MOTOROLA

MC68341

ADDENDUM TO MC68341 Integrated Processor User's Manual

April 19, 1995

Figure 3-12. M68300 Write Cycle timing

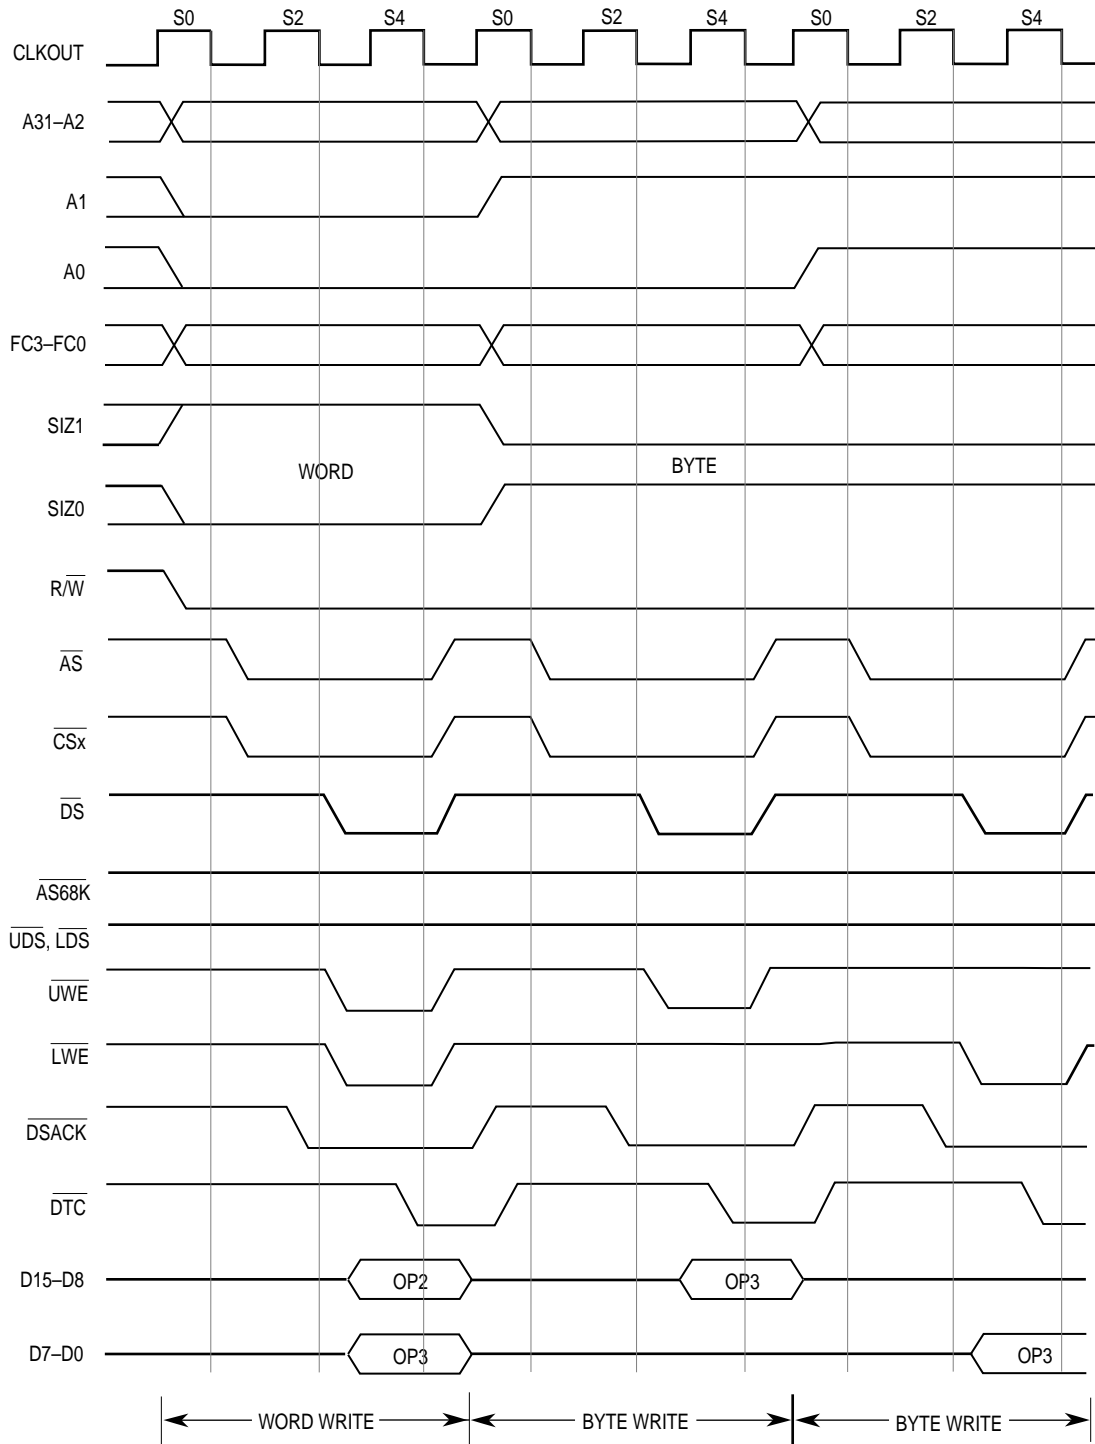
On page 3-25, the M68300 write cycle timing diagram (Figure 3-12) shows incorrect timing for \overline{DS} , \overline{UWE} , and \overline{LWE} . On page 3-28, the M68000 write cycle timing diagram (Figure 3-14) shows incorrect timing for $\overline{AS68K}$, \overline{CSx} , $\overline{UDS/LDS}$, and $\overline{UWE/LWE}$. Replace these figures with the following corrected figures.

Figure 11-2. Sample Crystal Circuit

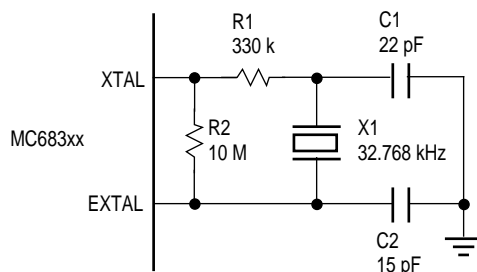
On page 11-2, Figure 11-2, a 10M resistor can be substituted for the 20M R2 bias resistor as shown below.

Figure 11-14. Circuit For Interfacing 8-Bit Device to 16-Bit Memory in Single-Address DMA Mode

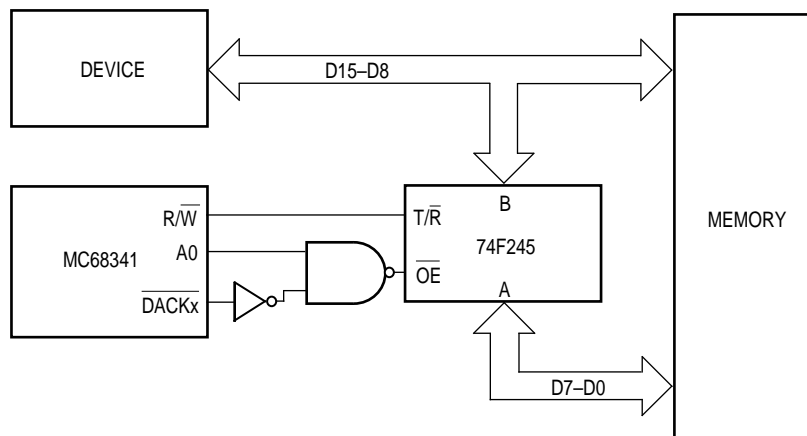
On page 11-10, the logic driving \overline{OE} on the 74F245 in Figure 11-14 should be corrected as shown below. Although not detailed, the byte enables for the memory block should be controlled during reads to prevent contention between the upper and lower bytes of the data bus when D7-D0 is muxed to the upper data byte.

80. Page 9-19,

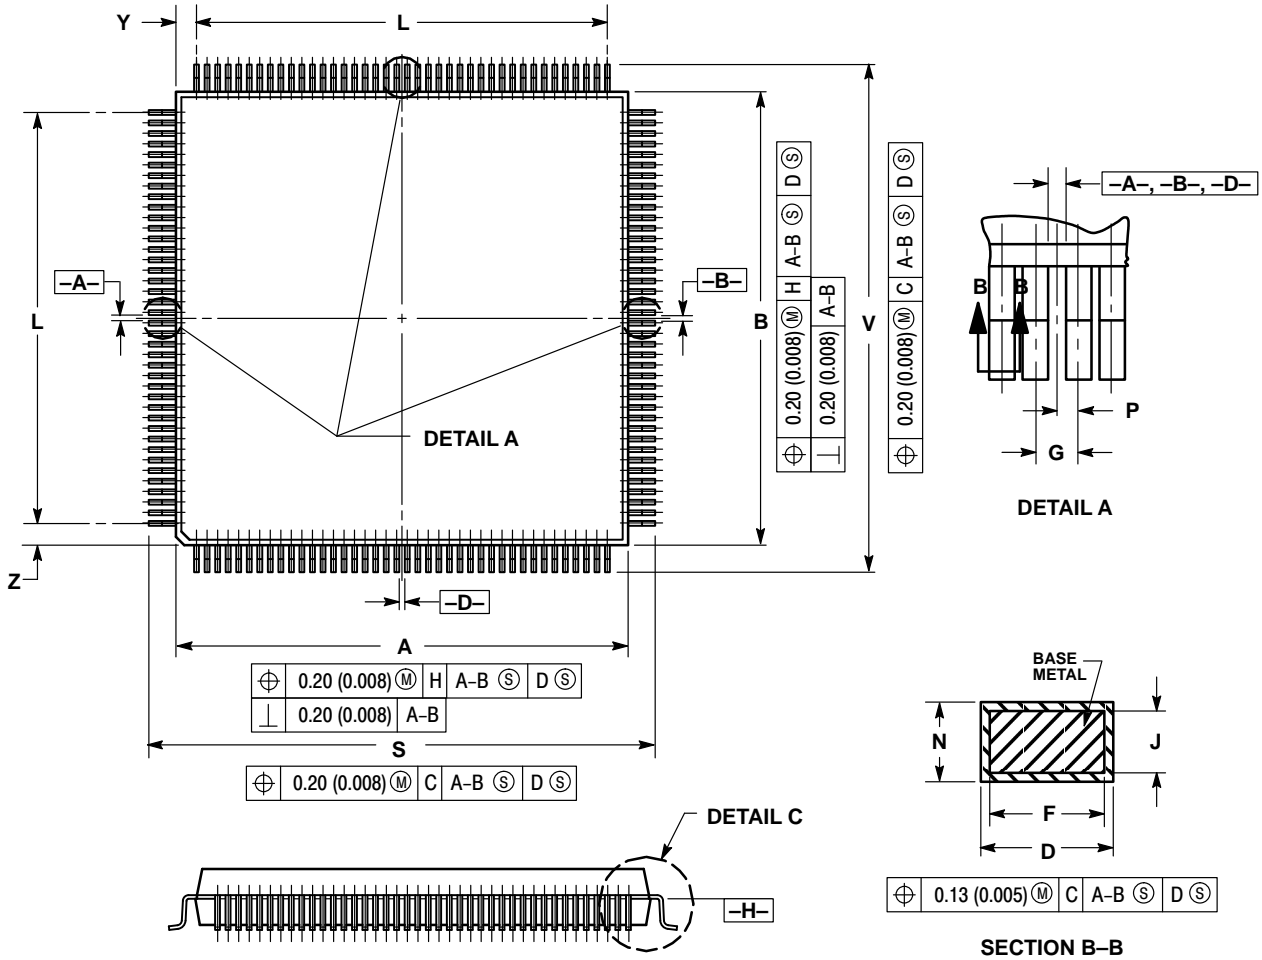
The timing diagrams reference as Figures 9-24 — 9-27 should be changes to 12-22–12-25.
